BOARD OF ZONING ADJUSTMENT
FOR THE DISTRICT OF COLUMBIA

Appeal of Nebraska Avenue Neighborhood Association From Decision of DCRA Issuing Building Permits B456618 & B454315 with respect to Sunrise Assisted Living Facility Located at 5111 Connecticut Ave, N.W. In R-2 and R-5-B Zone (Square 1989, Lot 162)	))))))	Appeal No. 17127

Nebraska Avenue Neighborhood Association
Response to Sunrise and DCRA 5/4/2004 Submissions
Re: Motion to Dismiss

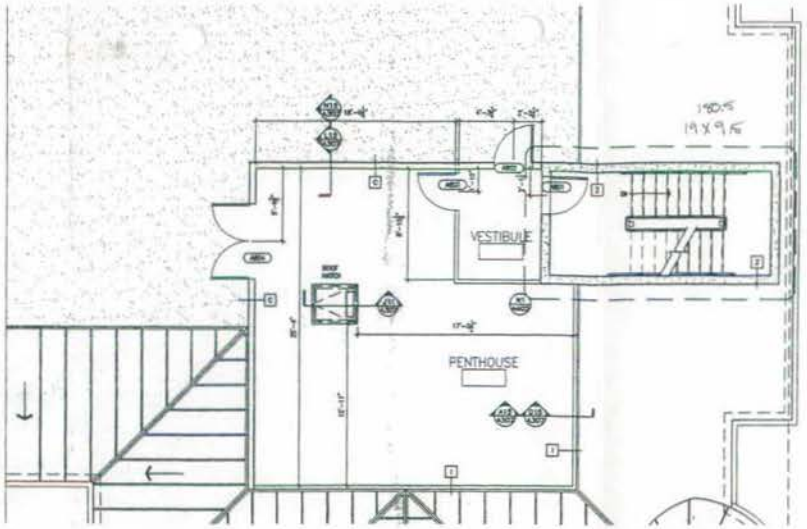
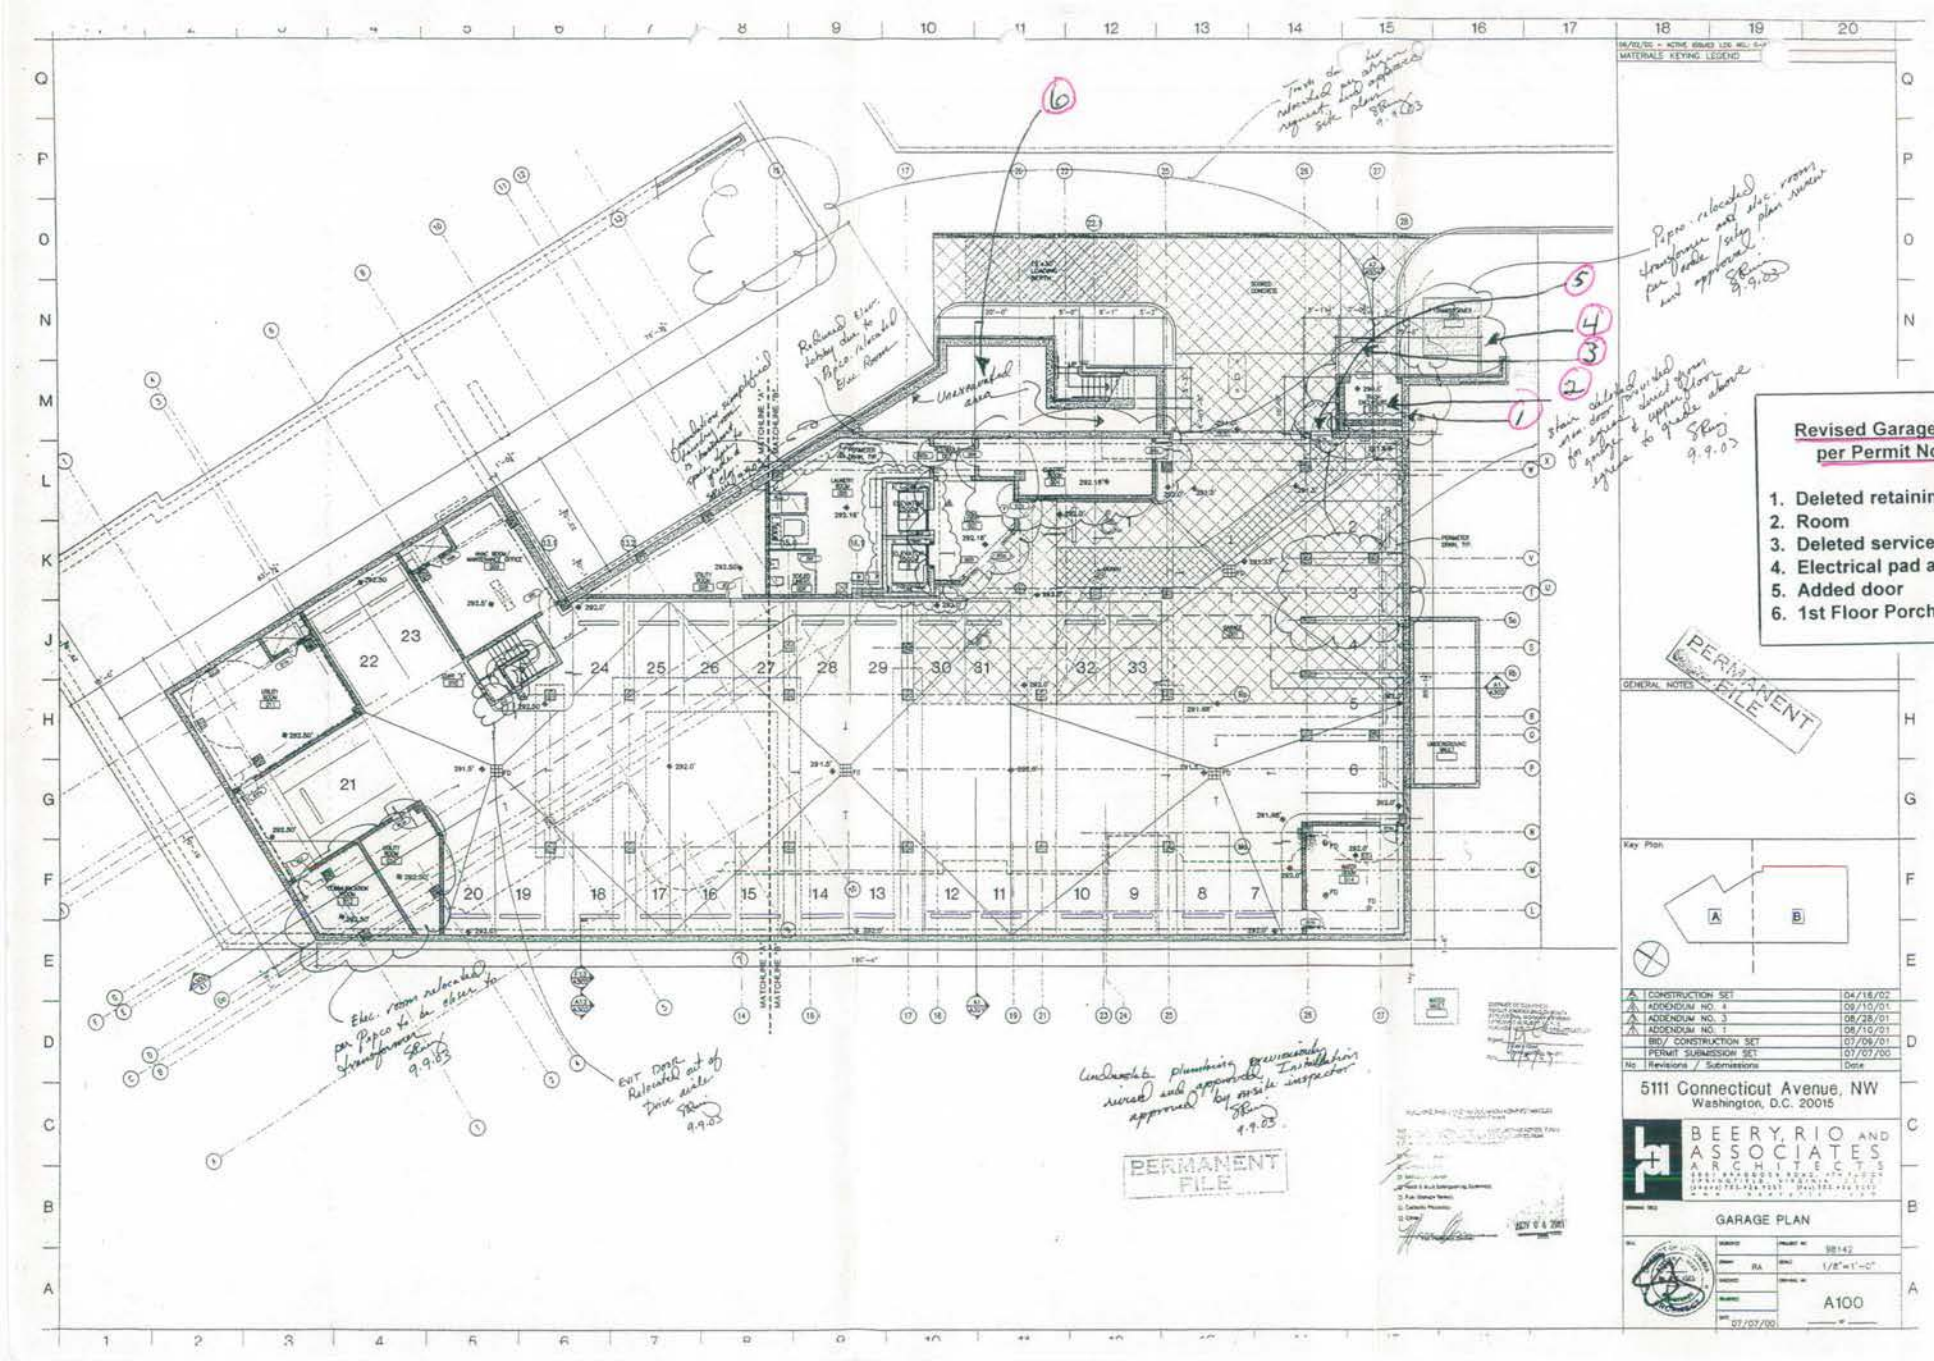
- The so-called trash enclosure is inaccurately described. It a full room (floor, roof, 10-ft tall walls, 2 doors) integrally constructed with the building. It is 10 feet wide and extends into the required rear yard 9.5 feet. It's floor and doors (not its roof) are at external grade (alley) level. (Zoning consequences -- gross floor area/FAR, rear yard requirements, loading/delivery space requirements).

- Removal of an interior stair (no zoning consequences).
- Door added next to the trash enclosure (after removal of retaining wall in this location (**zoning consequences** due to lowering adjacent grade); modifying vehicle entrance ("roll" door) into garage (no zoning consequences).

- Retaining notes that a wall was added in the south side yard. However, Sunrise does not mention addition and deletion of other retaining walls, including deletion of retaining walls formerly used to raise adjacent grade at the rear of the building. These deletions have **zoning consequences** for gross floor area and FAR).

1) A pedestrian access door and a trash room have been added at the garage level. In the original plans, the area that now contains these two features were shown as earth mounded against the building. Thus, the amount of cellar has been reduced and the amount of basement has been increased. This increases the FAR of the project over that allowable.

2) The trash room noted above intrudes into the required minimum rear yard space.

3) An electrical transformer, that was not shown on the original plans, has been placed in one of the two required loading spaces. This required loading space has not been replaced. Thus the project only contains one loading space which forces loading to occur in the alley.

Revised Roof Plan
per Permit No B454315

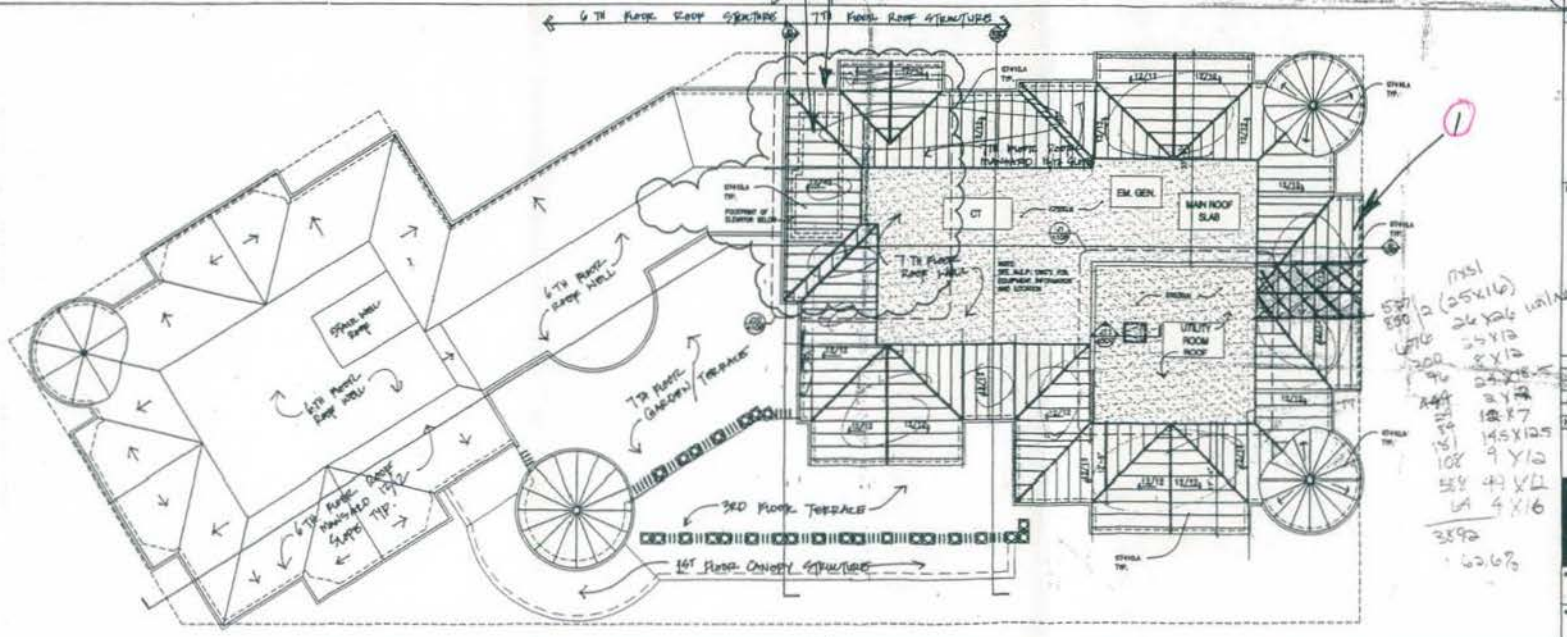
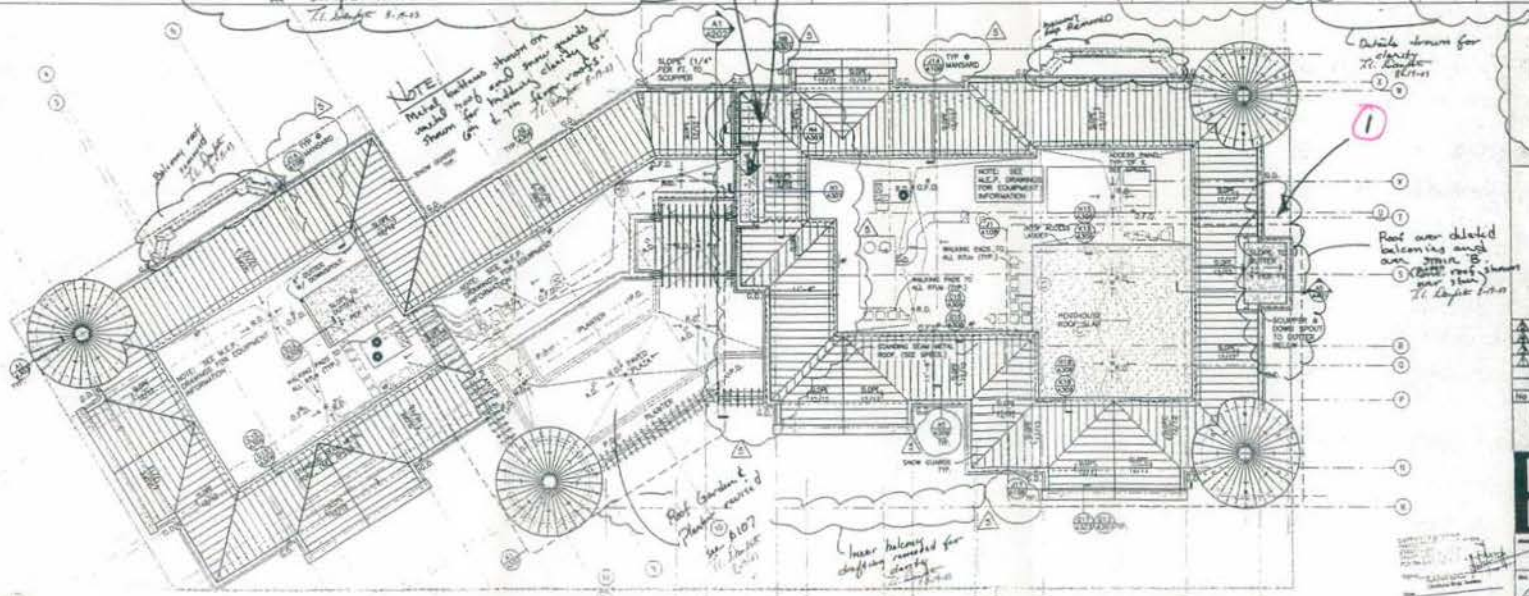
- No approved plan shows the reduction in gross floor area on the 6th floor claimed by Sunrise. No zoning consequences.
- Deletion of 7th floor external balconies (porches). *Removal of enclosures around the south stairwell has* ***zoning consequence*** *for 7th floor roof penthouse setbacks.*

- Installation of planters and cabinets and movement of doors (no zoning consequences)
- Elimination of roof over two covered balconies (enclosing south stairwell and south stairwell penthouse --*no reduction* in gross floor area as these porches were not counted in gross floor area; **zoning consequence for penthouse setback and single penthouse**, BZA hearing Aug. 3, 2001, transcript pp 159, 164, 165)

Revised 1st Floor Plan per Permit No. B435464

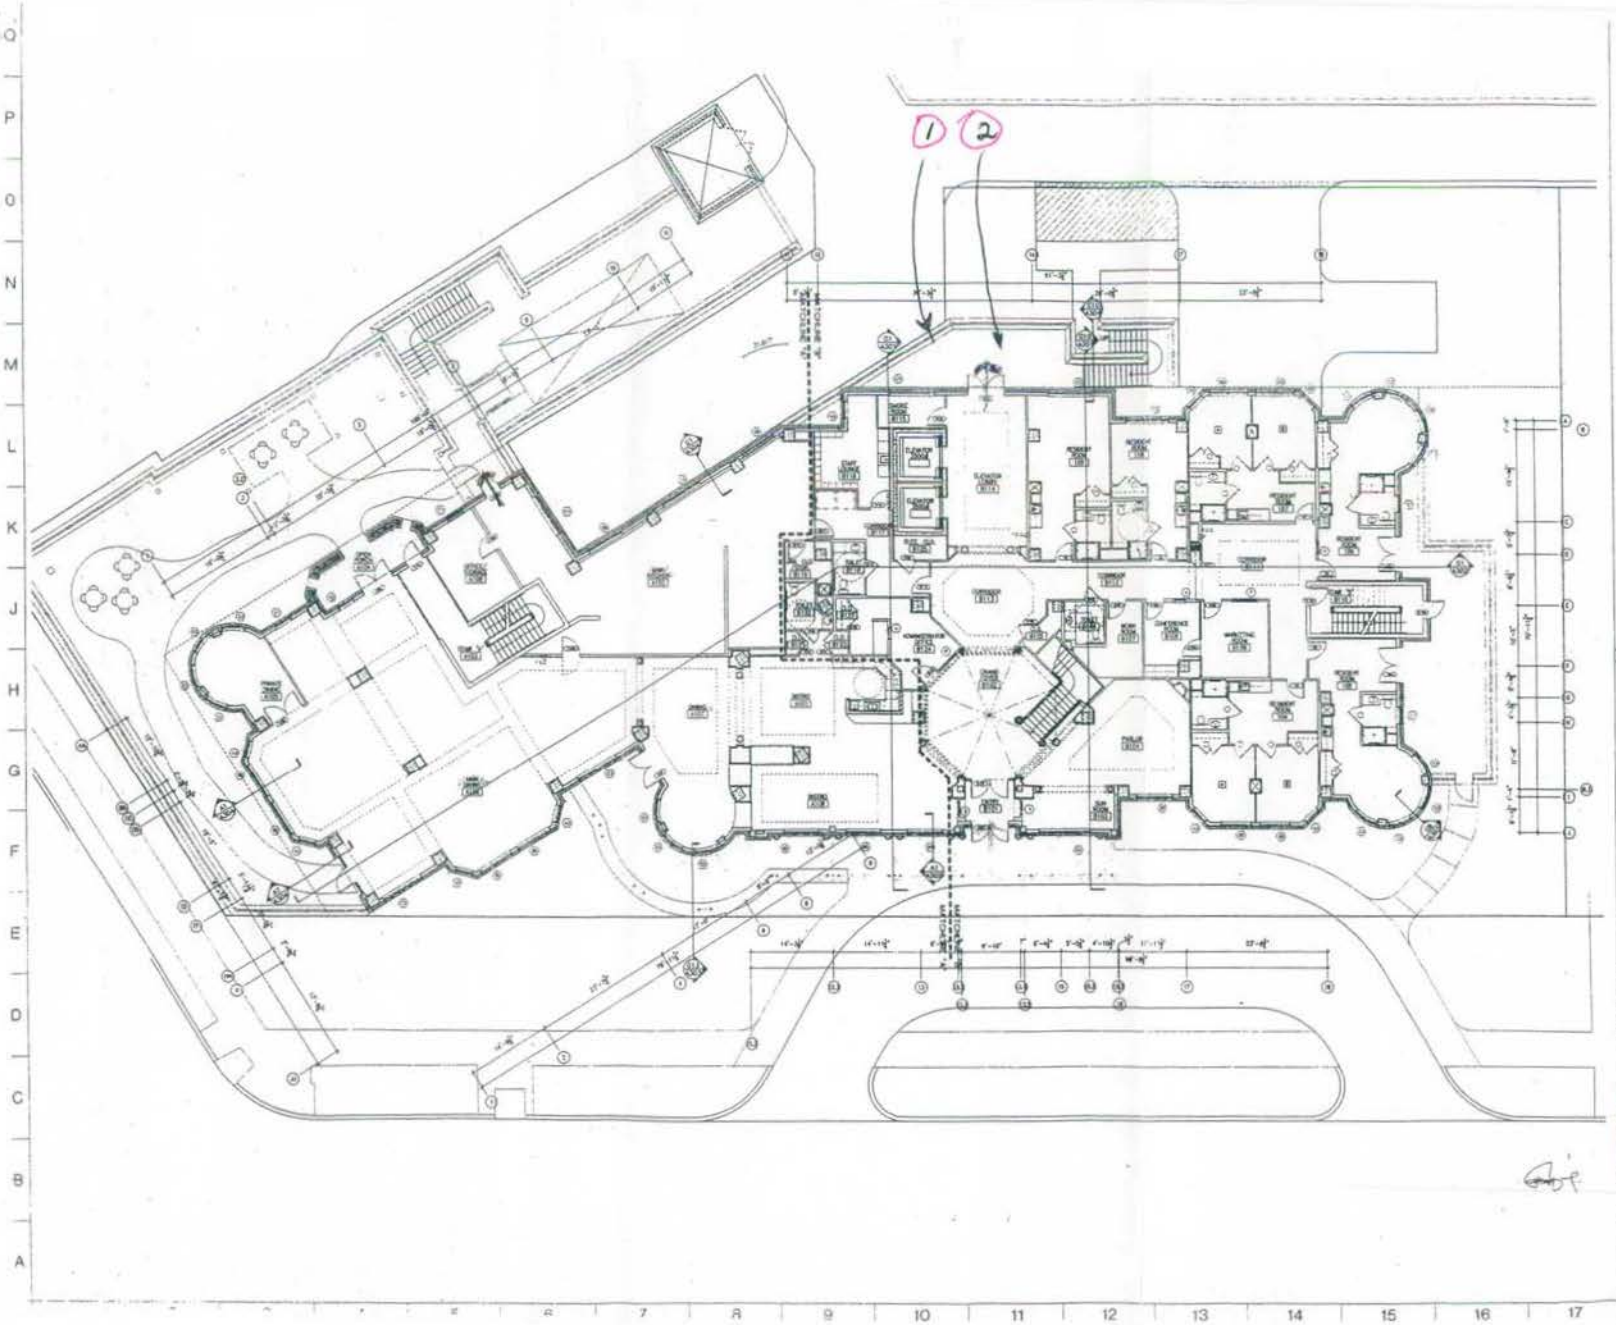
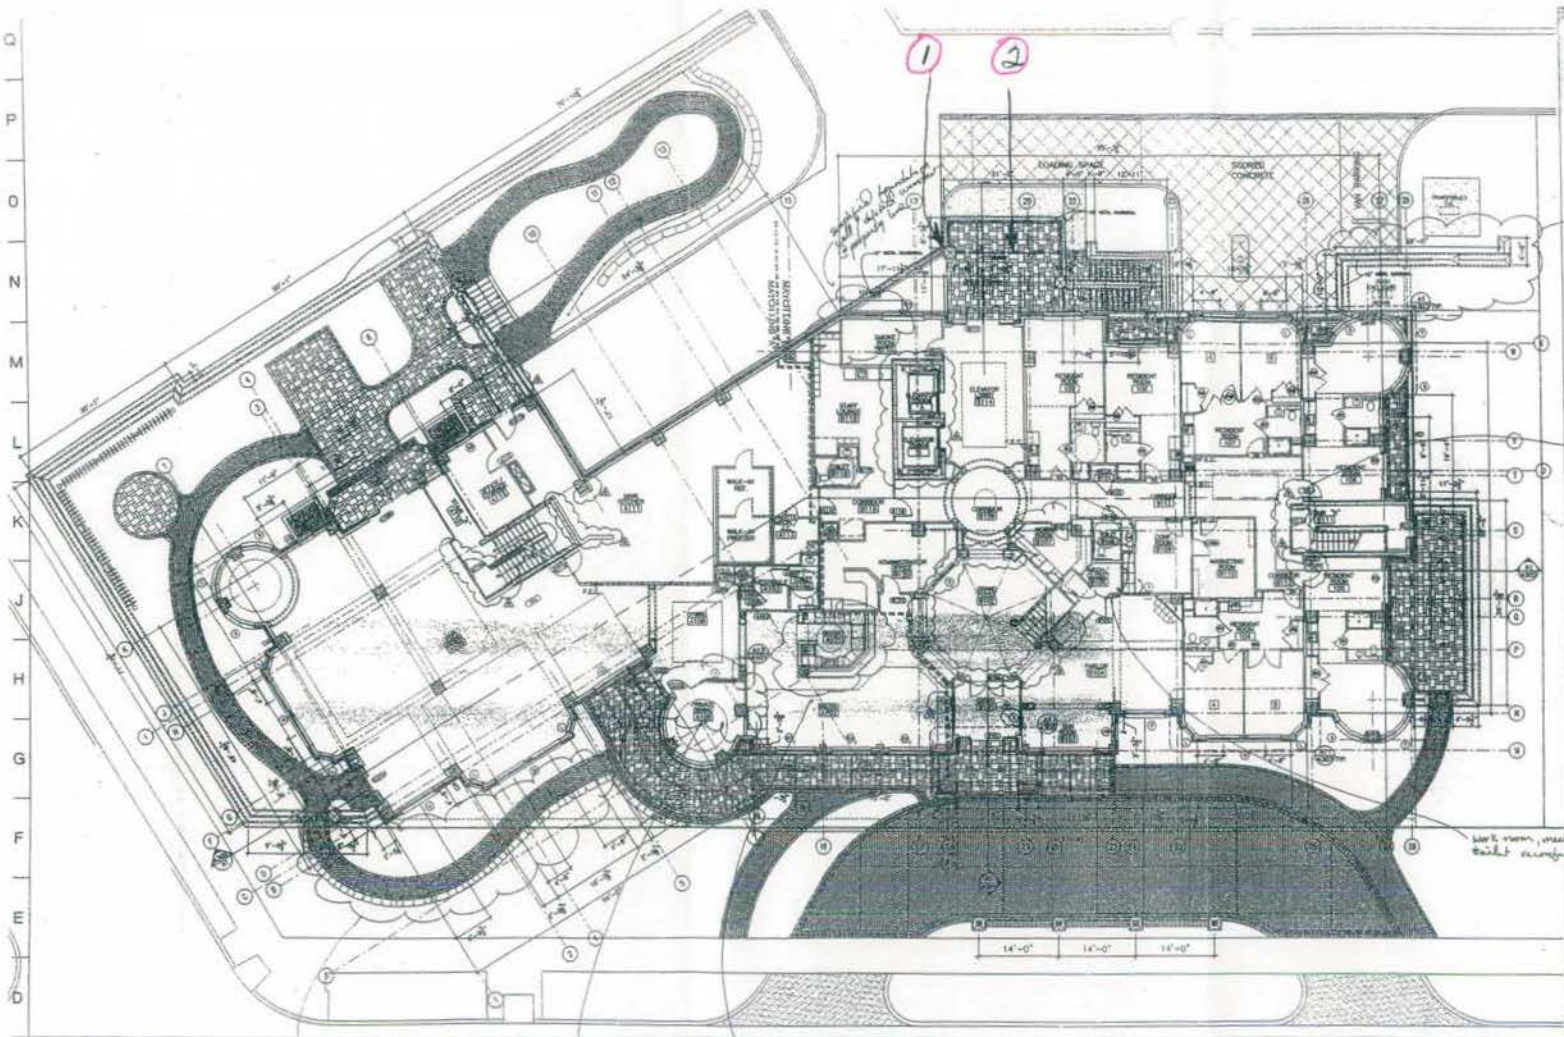
1. Deleted retaining wall
2. 1st Floor Open Porch

View of South Stairwell with Roof Penthouse on top

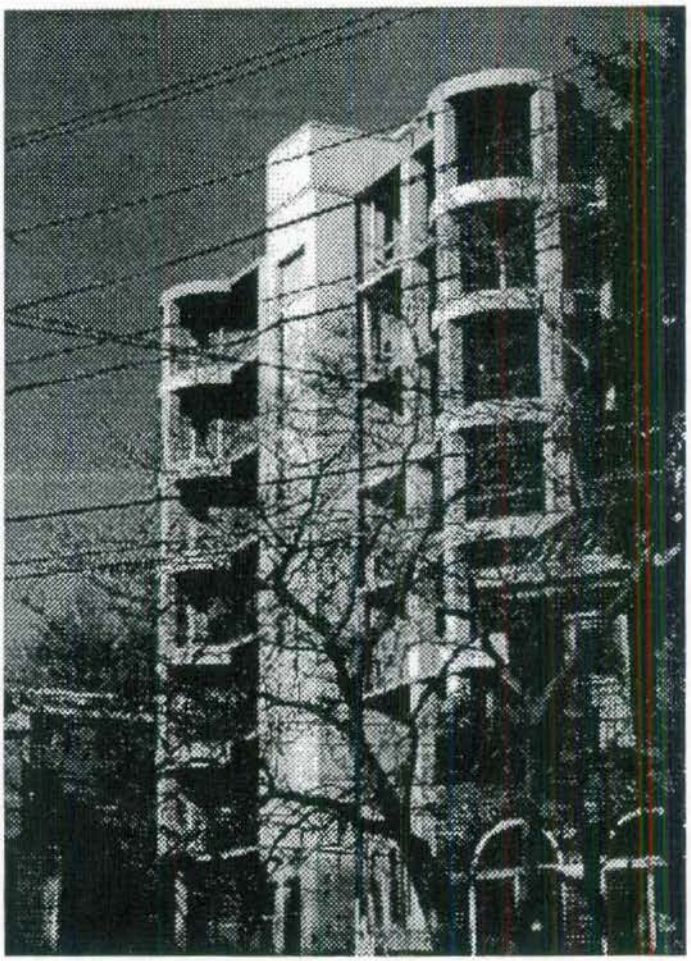
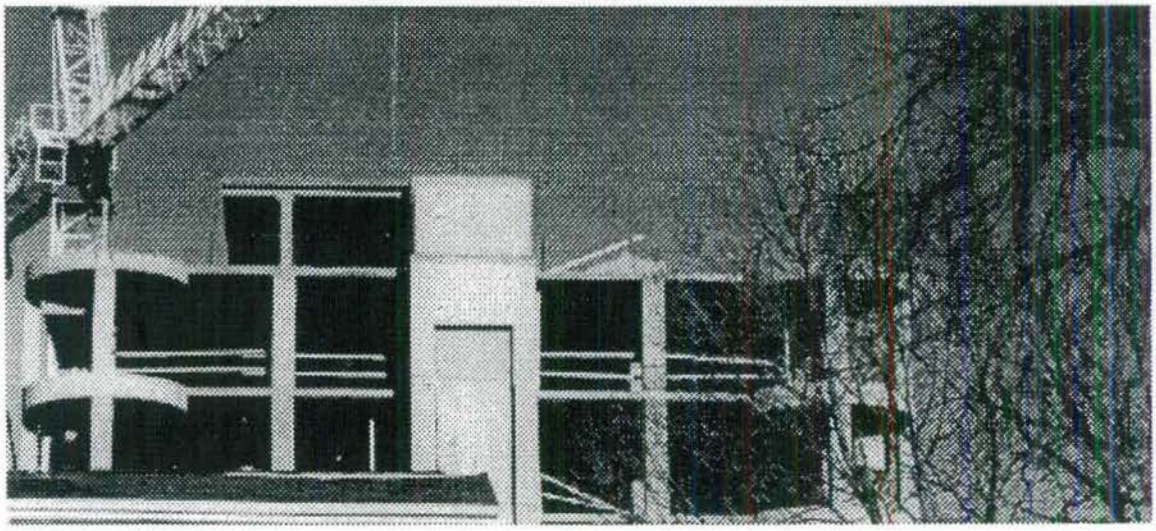
The south roof penthouse has no setback from the exterior wall.
